MEETING:	PLANNING AND REGULATORY COMMITTEE
DATE:	17 JANUARY 2024
TITLE OF REPORT:	163932 - OUTLINE PLANNING APPLICATION FOR A SUSTAINABLE URBAN EXTENSION COMPRISING: UP-TO 250 DWELLINGS; OPEN SPACE, ALLOTMENTS AND LANDSCAPING; SCHOOL EXPANSION LAND; AREAS OF CHILDREN'S PLAY; SUSTAINABLE URBAN DRAINAGE INFRASTRUCTURE; INTERNAL ROADS; AND ASSOCIATED INFRASTRUCTURE. DETAILED APPROVAL IS SOUGHT FOR PRINCIPAL MEANS OF ACCESS AND LAYOUT WITH ALL OTHER MATTERS RESERVED AT LAND AT HARDWICK BANK, BROMYARD, HEREFORDSHIRE, For: Vistry Homes Limited and Mosiac Estates per Russell Smith, McLoughlin Planning, 119 Promenade, Cheltenham, GL50 1NW
WEBSITE LINK:	https://www.herefordshire.gov.uk/info/200142/planning_services/planning_application_search/details?id=163932&search-term=163932
Reason Application submitted to Committee - Redirection

Date Received: 7 December 2016 Ward: Bromyard West Grid Ref: 364358,254665

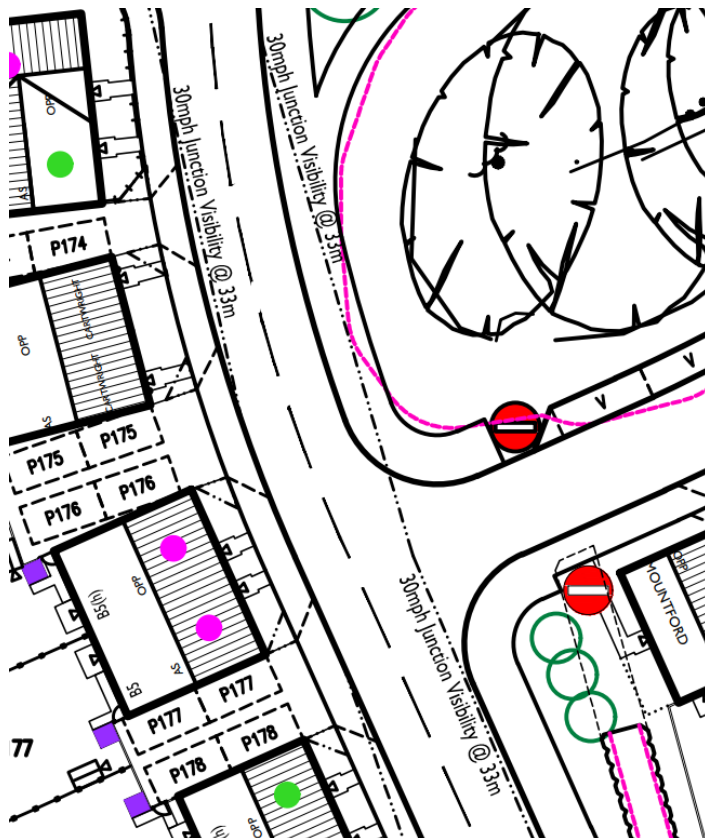
The proposed access junction would comprise of a three arm signalised junction with no pedestrian or cycle facilities. In addition, it has been established that should it be necessary to allow for development to the south to go ahead it would be possible to accommodate a fourth arm at the site access.

Junction capacity assessments have been undertaken for the site access. These demonstrate that the access arrangement would operate well within theoretical and practical capacity, even if a fourth arm was included. In addition, capacity assessments have been undertaken for both the A44/Winslow Road junction and the A44/Panniers Lane junction with the assessments demonstrating that both junctions have plenty of spare capacity even with the proposed development.

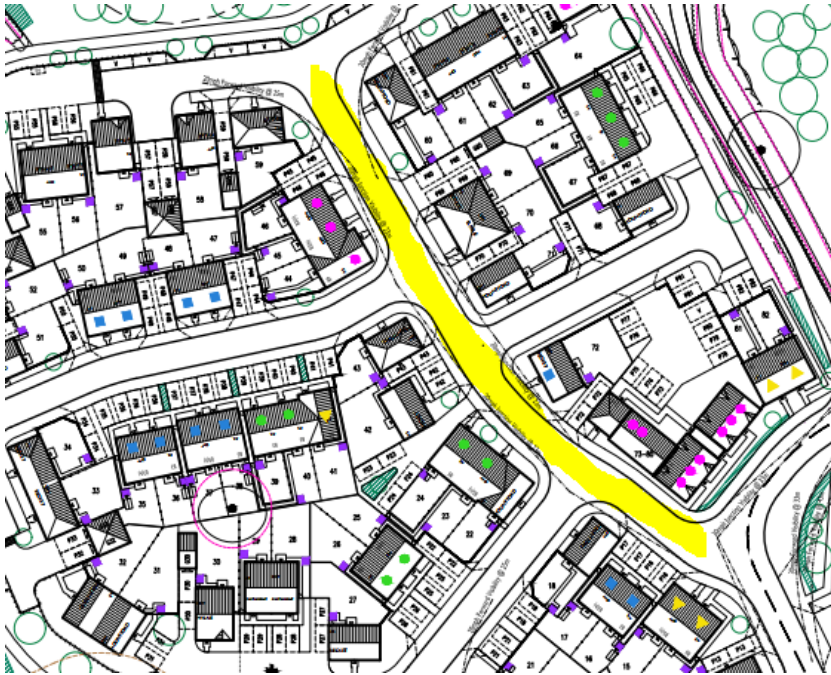
Another example is given below, not only is the x distance not 2.4m it isn't even taken from the centre of the junction.

These are concerns that have been raised on a number of occasions with the applicant, however, the applicant has been unwilling to amend them. The only avenue available to get the splays rectified is to add their correct provision as a condition of planning consent, especially given that the LHA is unable to adopt the roads within the site.

1. A plan demonstrating visibility splays of 2.4m x 33m with the splay being delineated by the back of the footway at all junctions should be provided prior to commencement on site for the approval by the LHA/LPA. Nothing over 0.6m in height should be placed within the splays. This condition overrides the visibility splays demonstrated on drawing 0687-102.

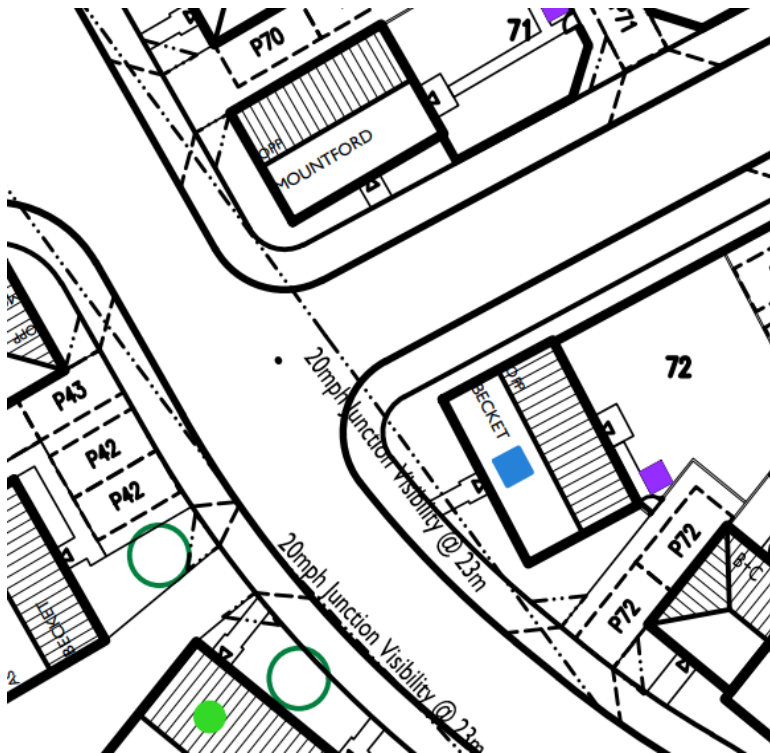
Another issue concerning visibility splays is the length of the splays on the side roads. The applicant has provided splays of 2.4m x 23m. However, splays of this length are for streets which serve lower numbers of dwellings, are constrained in width and do not have a straight alignment. The below screenshot shows one of the roads where 23m visibility splays are provided, the road is wide at 5.5m and of a reasonably straight alignment, therefore the ability to constrain speeds is limited due to its geometric features.

Our Highway Design Guide for New Developments states that for roads which serve between 25 and 100 dwellings (the above example serves 66 dwellings) should be 5.5m in width, as the above example is, and have visibility splays of 33m. Therefore visibility splays of 2.4m x 33m have been requested on a number of occasions, however, the applicant has been unwilling to provide them.
